Date: March 17, 2014

To: Alcoa, San Antonio Works

Recommended changes to relocate downdraft table

Recommended change in layout drawing to accomodate Alcoa

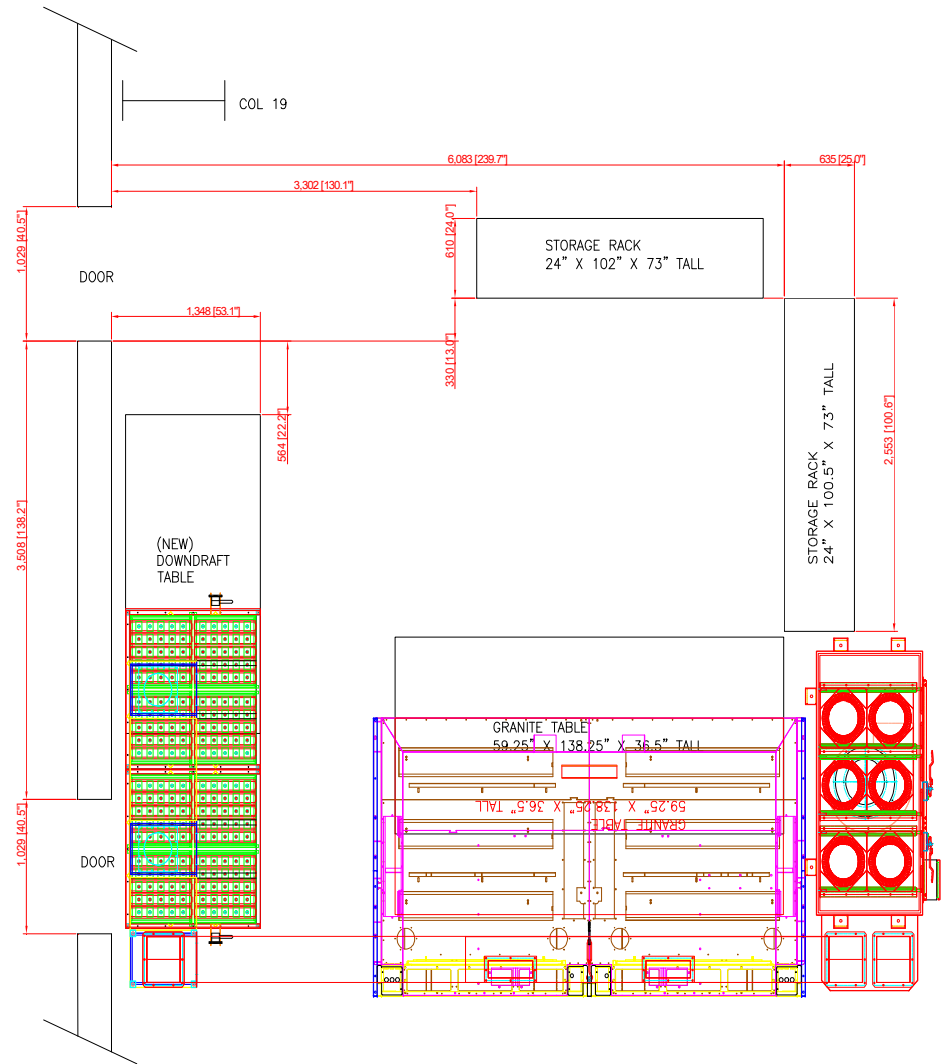
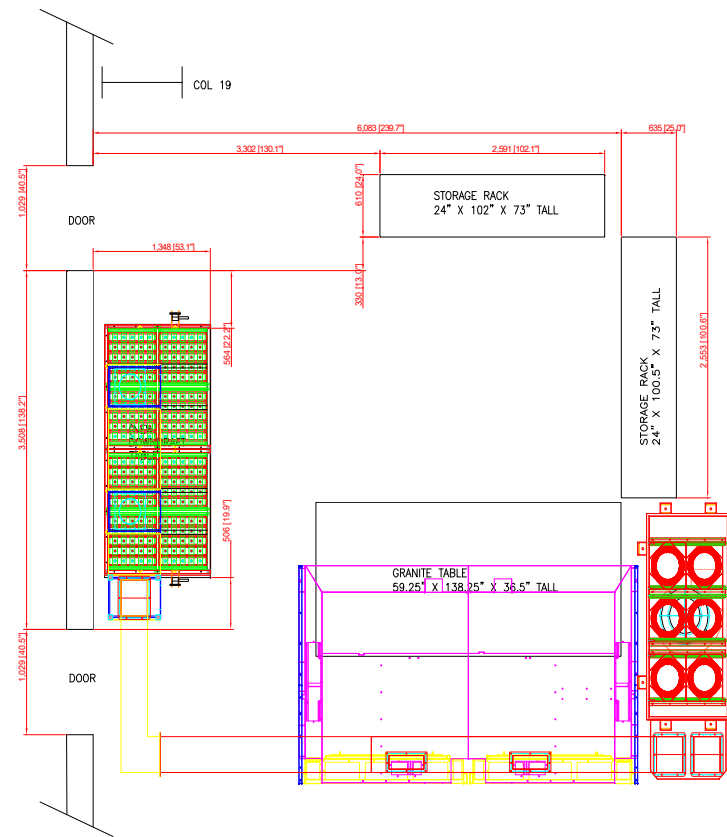
*Downdraft table is blocking the door

*Add ductwork to relocate downdraft table away from door

*Additional ductwork

Add ductwork to move the downdraft table
away from obstructing the door
